CAFO FACILITY INSPECTION REPORT

<u>8335286001A</u> WDID NUMBER	<u>Pete Vanderham</u> OWNER NAME	<u>Pete Vanderham Dairy</u> FACILITY NAME
<u>CAG018001</u> NPDES NUMBER	<u>Ex. 6 Personal Privacy (PP)</u> OWNER ADDRESS FACILITY ADDRESS	
<u>R8-2007-0001</u> RWQCB ORDER NO.	<u>Mira Loma, CA 91752</u> OWNER CITY AND STATE	<u>Mira Loma, CA 91752</u> FACILITY CITY AND STATE
<u>03/07/2013</u> SCHEDULED INSPECTION DATE	<u>Pete Vanderham</u> OWNER CONTACT	<u>Pete Vanderham</u> FACILITY CONTACT
<u>03/07/2013</u> ACTUAL INSPECTION DATE	<u>Ex. 6 Personal Privacy (PP)</u> OWNER PHONE NO. FACILITY PHONE NO.	
<u>Unknown</u> RECEIVING WATER	<u>Ex. 6 Personal Privacy (PP)</u> FACILITY LATITUDE	<u>Ex. 6 Personal Privacy (PP)</u> FACILITY LONGITUDE

On March 7, 2013, a Concentrated Animal Feeding Operation (CAFO) inspection was conducted for Santa Ana Water Board Order No. R8-2007-0001 - 'General Waste Discharge Requirements for Concentrated Animal Feeding Operations (Dairies and Related Facilities) within the Santa Ana Region', NPDES General Permit No. (CAG018001) at Pete Vanderham Dairy in Mira Loma, California (refer to Photo 1). The inspector met with Mr. Pete Vanderham (Owner, Pete Vanderham Dai

Photograph 4. View facing southeast of basin D. Note the basin did not contain a depth marker. Also note accumulated solids were observed in the basin. A concrete spillway was located in the southwest corner of the basin.

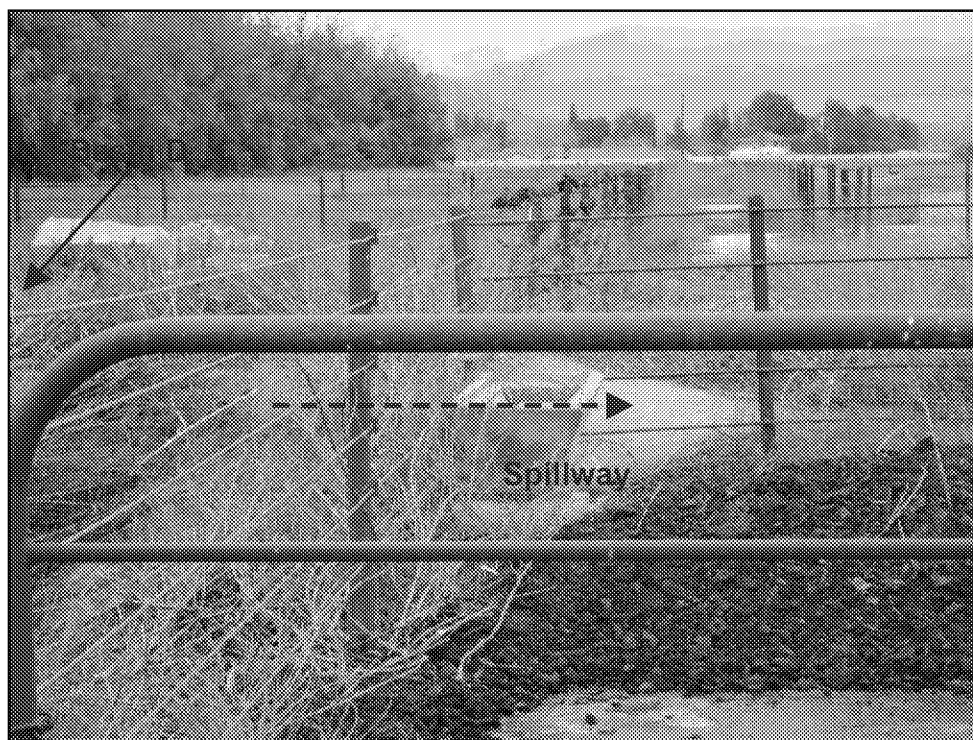
1. Depth markers were not installed in basins A, B, and C, located in the northern portion of the Facility, or in basin D located in the southeastern portion of the Facility, as required by Permit Attachment B - Monitoring and Reporting Program, Section I.B.1 (refer to Photos 4, 6, 9, 10, and 12). This is a recurring issue identified in a previous inspection conducted on December 9, 2011.

1. The inspector observed, during the inspection, that depth markers had not been not installed in basins A, B, and C located in the northern portion of the Facility, and in basin D located in the southeastern portion of the Facility as required by the Permit (refer to Photos 4, 6, 9, 10, and 12). Permit Attachment B - Monitoring and Reporting Program, Section I.B.1 states that "a marker shall be placed within each pond or impoundment to indicate the

4. The inspector observed, during the inspection, accumulated solids in basins A, B and C in the northern portion of the Facility, and in basin D in the southeast portion of the Facility (refer to Photos 4, 7, 11, and 12). Mr. Vanderham stated that the containment structures at the Facility are typically cleaned every summer, and were last cleaned in the summer of 2012. It should be noted that basins B, C, and D did not contain depth markers; therefore, the inspector was unable to determine the depth of accumulated manure solids in the ponds (refer to Photo 4). Section 1.5.4 - 'Operation and Maintenance Plan' of the approved EWMP states "prior to the wet cycle (beginning Oct. 15), accumulated solids and manure shall be removed from the holding ponds to reestablish the design capacity." As a result, the overall capacity of the basins at the Facility may be diminished. Provision VII.C.3.a of the Permit states that "the discharger shall design, construct, and maintain containment structures to retain all wastewater within the facility, including all process wastewater and all precipitation on, and drainage through, manured areas resulting from rainfall up to and including a 25-year, 24-hour rainfall event." The Discharger must design and maintain all containment structures per the approved EWMP as required by Provision VII.C.3.a of the Permit. This is a recurring issue identified in a previous inspection conducted on December 9, 2011.

Photograph 6. View facing north of basin B. Note the basin did not contain a depth marker. Also note a manure stockpile was located on the north side of the basin's berm, immediately south of basin A.

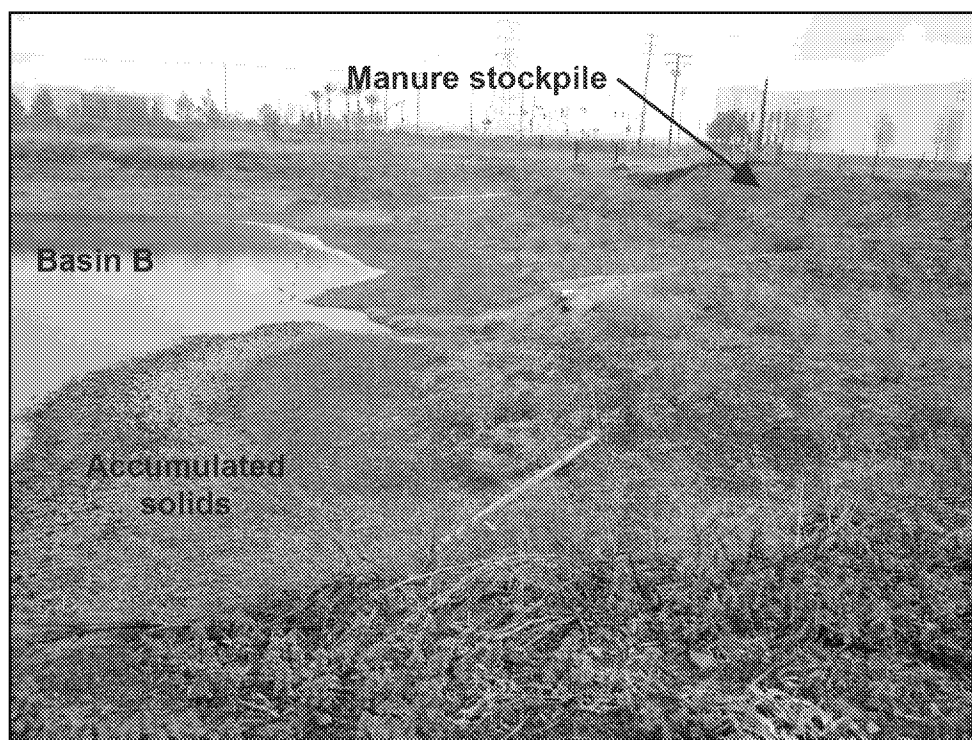
6. The inspector observed, during the inspection, that pond solids/manure had been stockpiled on the existing berms on the western side of basin C, the northern side of basin B, and the southwestern side of basin A (refer to Photos 6 through 9, 11, and 13). Provision VII.C.5.c of the Permit states "no containment structures shall be constructed of manure, and manure shall not be used to improve or raise existing containment structures." Mr Vanderham informed the inspector that the basins were last cleaned in the summer of 2012.

Photograph 12. View facing south of basin C. Note the basin did not contain a depth marker. Also note accumulated solids and vegetation growth was observed in the basin.

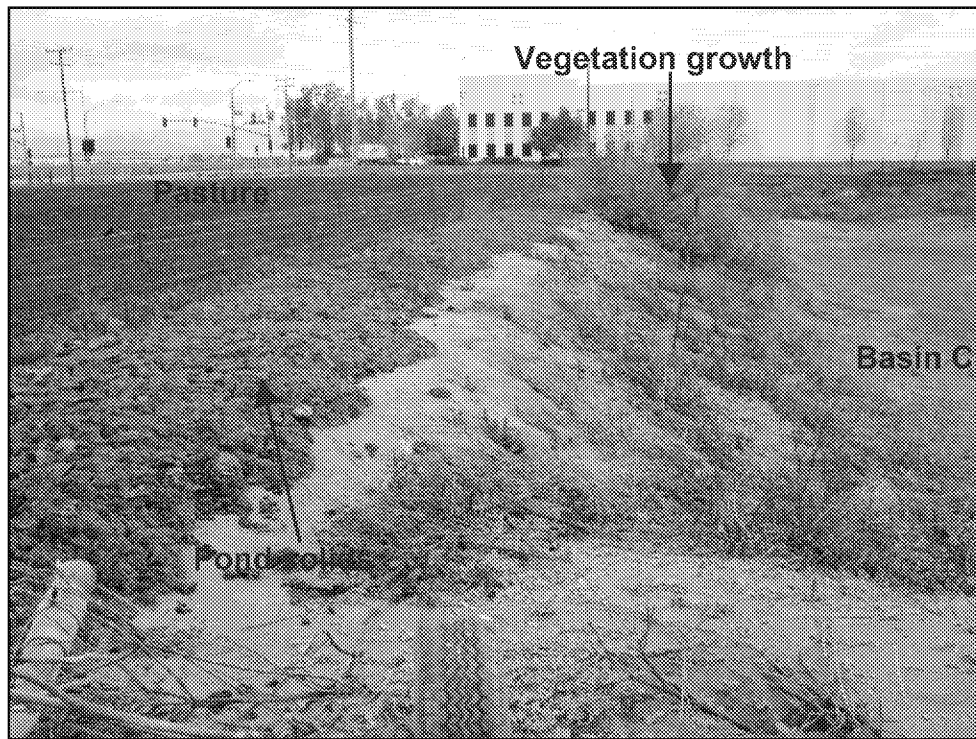
5. The inspector observed, during the inspection, that vegetation growth potentially affecting the containment structure capacity was present in basin C located in the northern portion of the Facility (refer to Photos 12 and 13). Section 1.5.4 - 'Operation and Maintenance' of the approved EWMP states that the Discharger shall "maintain weed control at the top and inside of the pond embankments. As a result, the overall capacity of the basin at the Facility may be diminished. Provision VII.C.3.a of the Permit states that "the discharger shall design, construct, and maintain containment structures to retain all wastewater within the facility, including all process wastewater and all precipitation on, and drainage through, manured areas resulting from rainfall up to and including a 25-year, 24-hour rainfall event." The Discharger must design and maintain all containment structures per the approved EWMP as required by Provision VII.C.3.a of the Permit. This is a recurring issue identified in a previous inspection conducted on December 9, 2011.

Photograph 16. View facing south of a previous release of manure offsite from the northwest pasture onto the Wineville Avenue right-of-way.

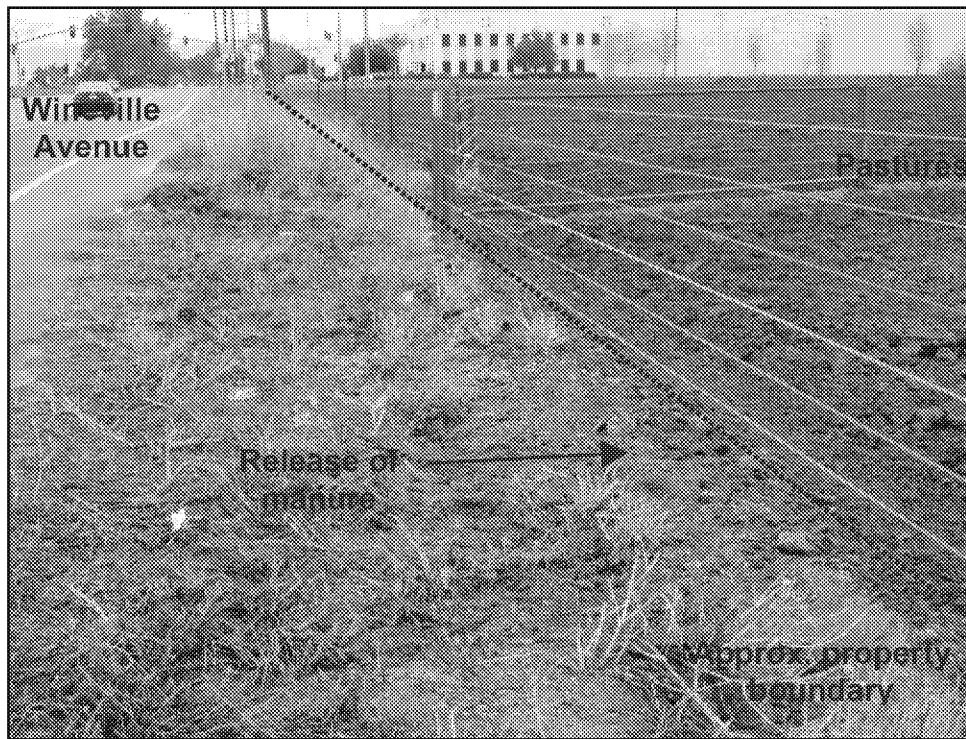
1. The inspector observed, during the inspection, a release of manure offsite onto Wineville Avenue right-of-way along the western Facility perimeter (refer to Photos 16 through 19). Manure was released offsite from the pastures in the northwest portion of the Facility (refer to Photos 16 and 17) and from the public manure stockpile located along the central-west Facility perimeter (refer to Photos 18 and 19). The inspector did not receive any information regarding the offsite release of manure from the Facility representative. It should be noted that an adequate contiguous containment berm had not been implemented along the western Facility perimeter. Discharge Prohibition IV.B of the Permit states "disposal of manure to land is prohibited." In addition, Effluent Limitations and Discharge Specification V.1.a of the Permit specifies that pollutants may be discharged from the Facility if "the production area is designed, constructed, operated, and maintained to contain all manure, litter, and process wastewater including the runoff and the direct precipitation from a 25-year, 24-hour rainfall event." This is a recurring issue identified in a previous inspection conducted on December 9, 2011.

Photograph 21. View facing south of a diesel fuel tank located on the northeast side of the feed barn. Note the tank did not contain secondary containment and diesel fuel product was observed on the impervious surface below.

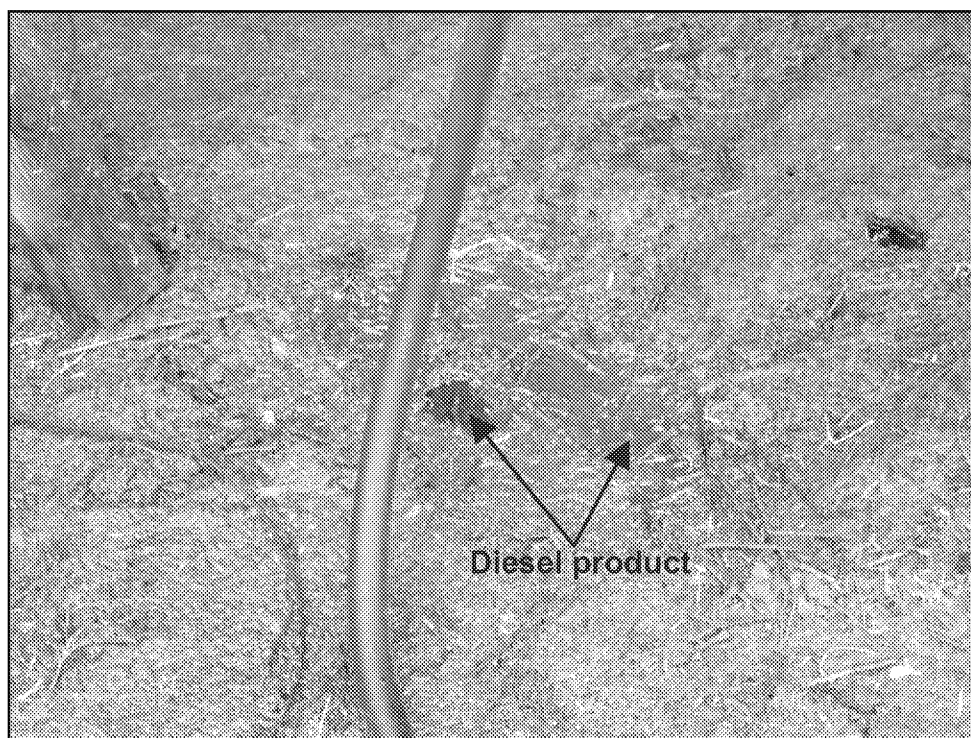
3. The inspector observed, during the inspection, that secondary containment was not provided for an elevated fuel storage tank on the northeast side of the Feed Barn (refer to Photo 21). Fuel product staining was observed on the impervious surface below (refer to Photo 22). Provision VII.C.5.h of the Permit states that "chemicals and other contaminants handled on-site shall not be disposed of in any manure, litter, process wastewater, or storm water storage or treatment systems." The inspector did not observe a disposal of chemical into any of the areas outlined above; however, the lack of secondary containment and staining creates a potential for chemicals to be spilled and/or contribute pollutants to storm water runoff on the impervious roadway.
